Point-by-point response to comments made by Reviewer #2

Figure 17: Rock-toppling susceptibility map of the Capitólio canyon.

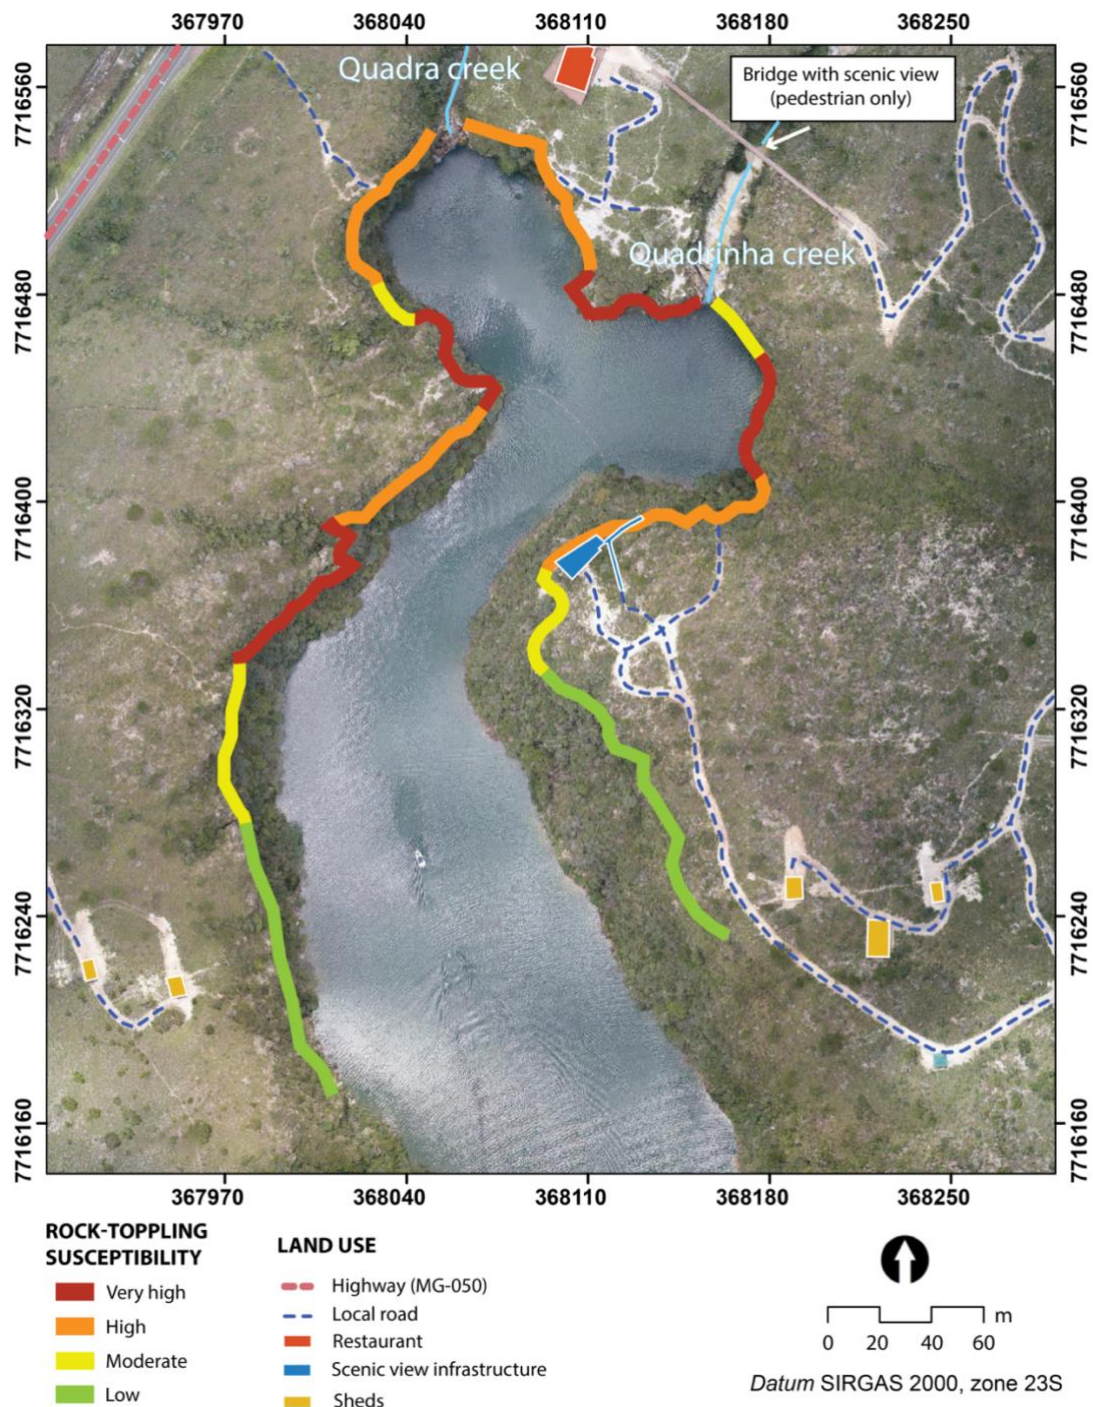
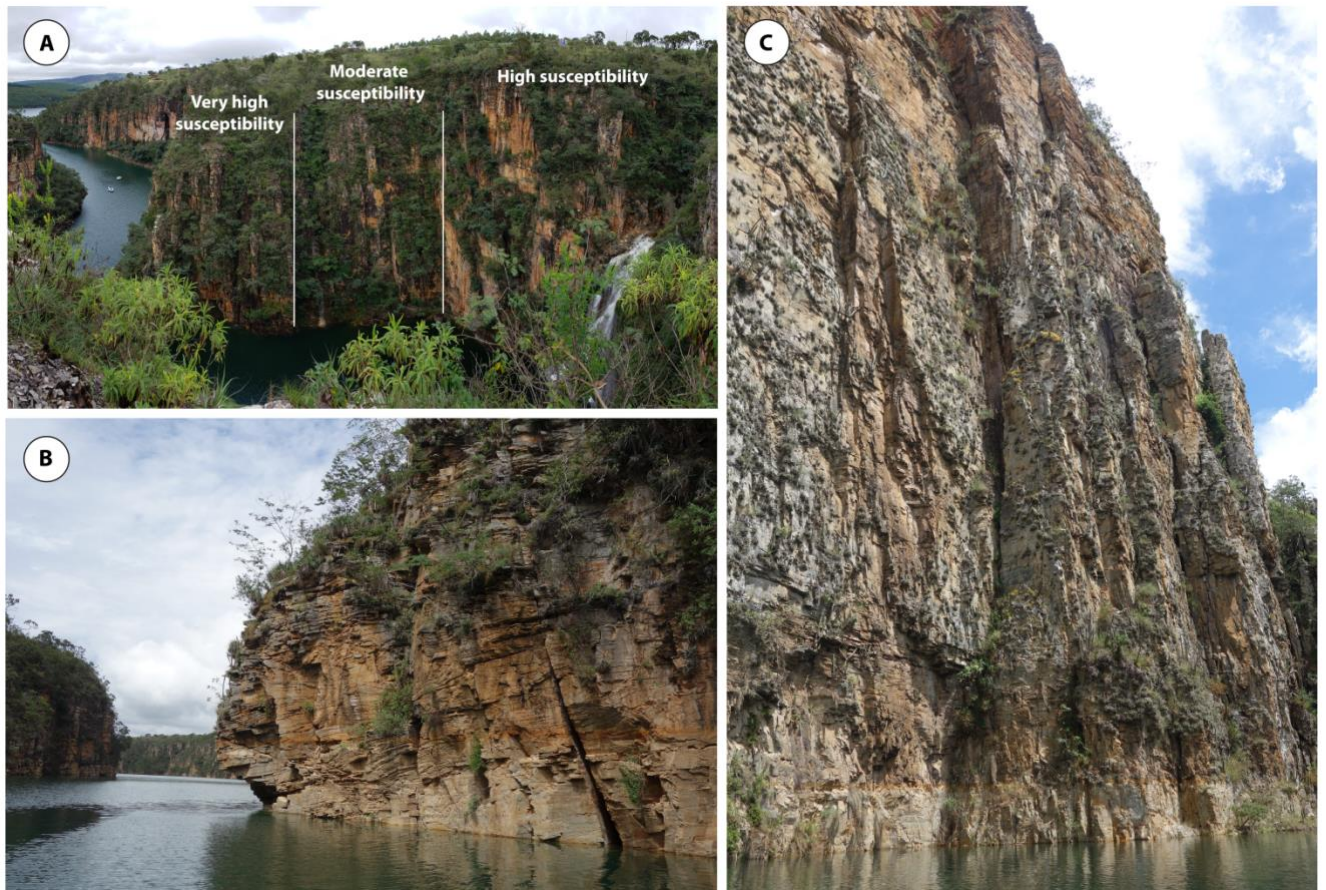
8. *A susceptibility map must also be produced, as well as an illustration of the identified structures that pose a problem for stability.*

Thanks for the suggestion and we agree that the susceptibility map is necessary. Based on the structural geology analysis, kinematic and stability assessments, as well as our field investigations, we created a susceptibility map with four susceptibility classes for the Capitólio canyon. Below, we detail the criteria for each class, which was included in the subchapter “4.4. Rock-toppling dynamics, susceptibility mapping and safety recommendations” of the revised manuscript:

To support the proposal of safety recommendations for the operation of the canyons, a rock-toppling susceptibility map is proposed (**Figure 17**), based on slope angle, geomechanical and kinematic analysis, as well as our *in situ* observations and structural geology investigation. The criteria, in priority order, for the delimitation of each susceptibility class are:

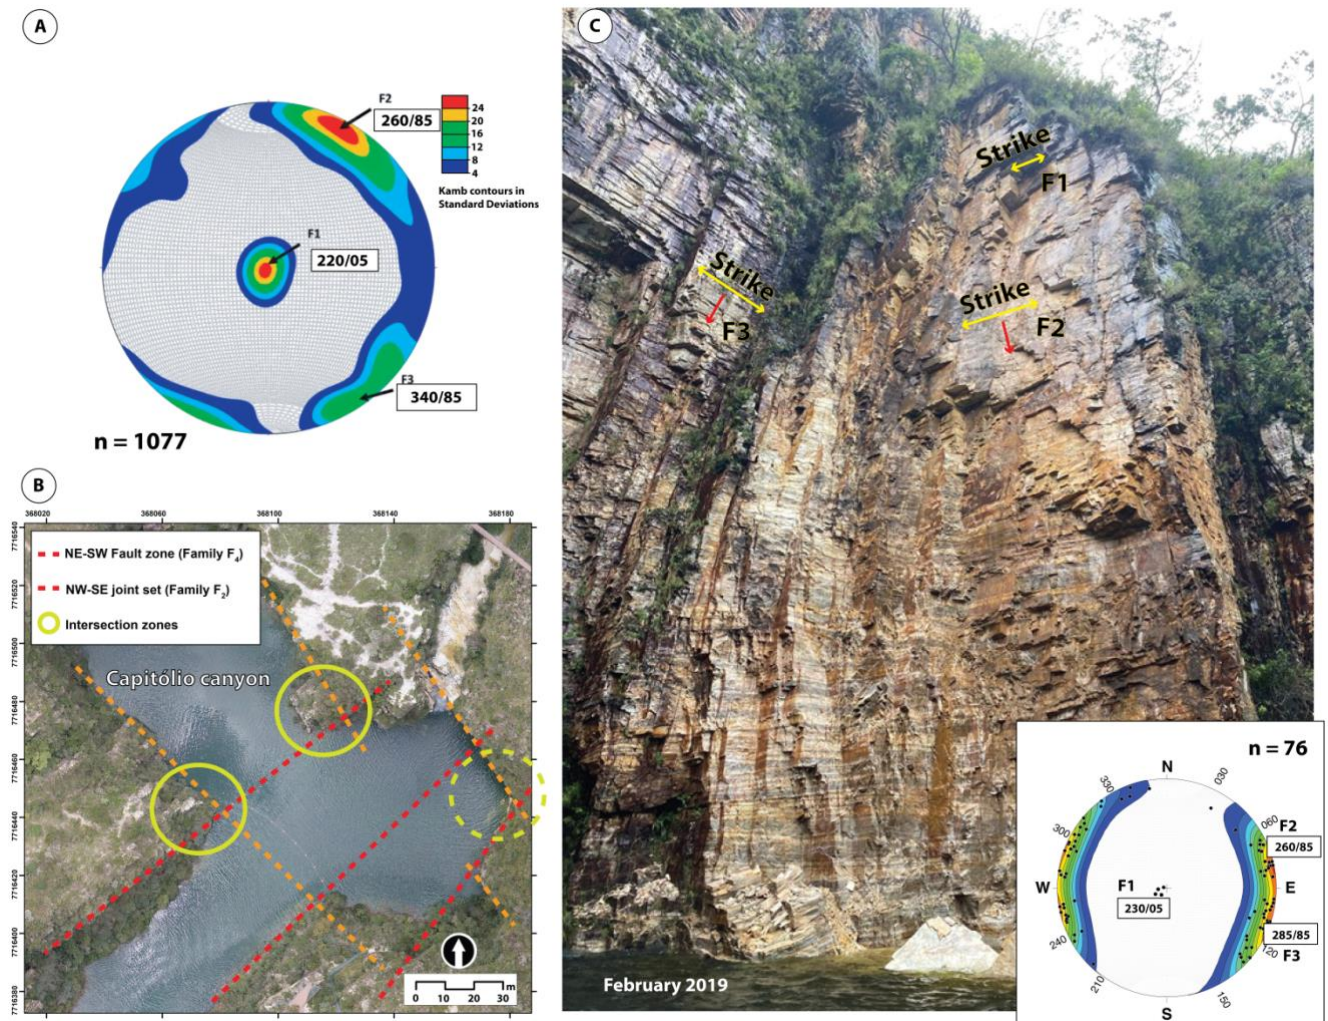
16. Figure 7: Add a stereonet and illustrate the discontinuities that play a role in the picture.

We have revised the Figure (now Figure 6) with the suggested alterations. The revised figure is below:

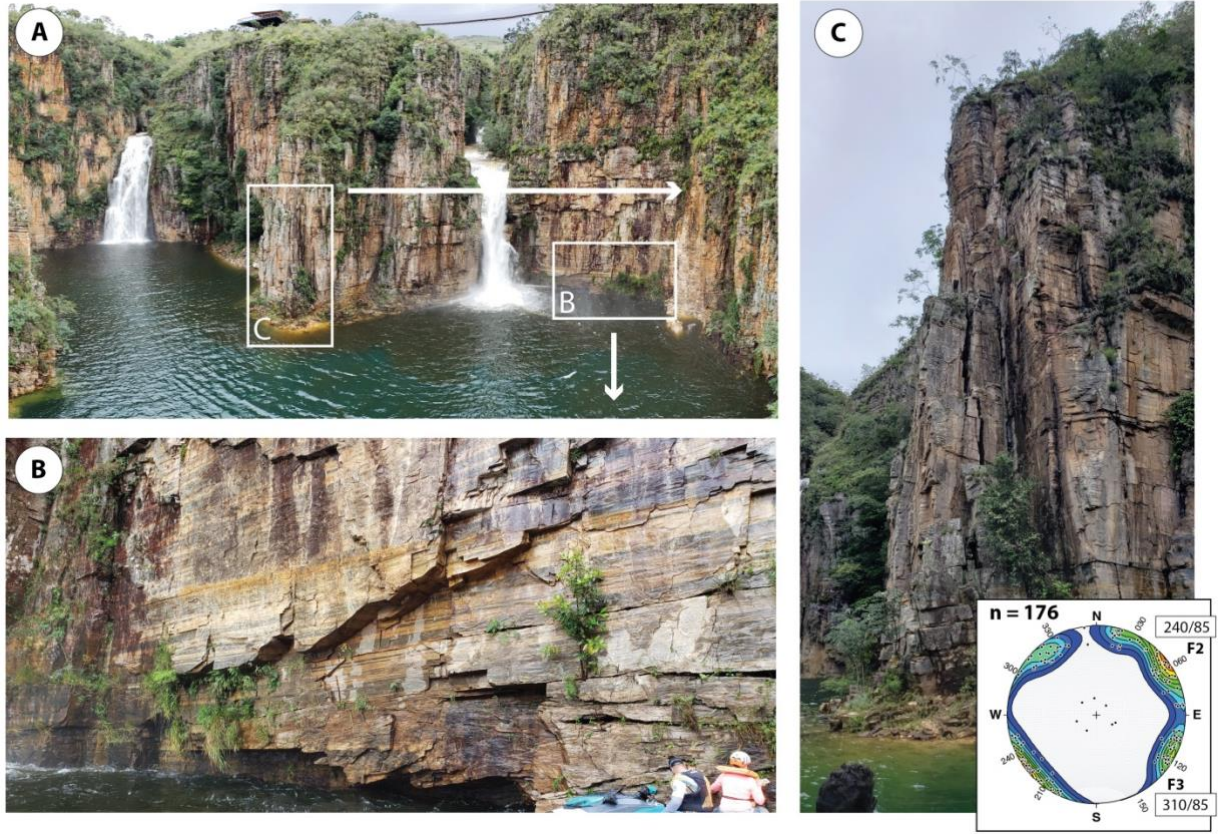
18. Figure 9: The same remarks apply as for Figure 7.

We have revised figure 9 (now Figure 15) based on the comments:
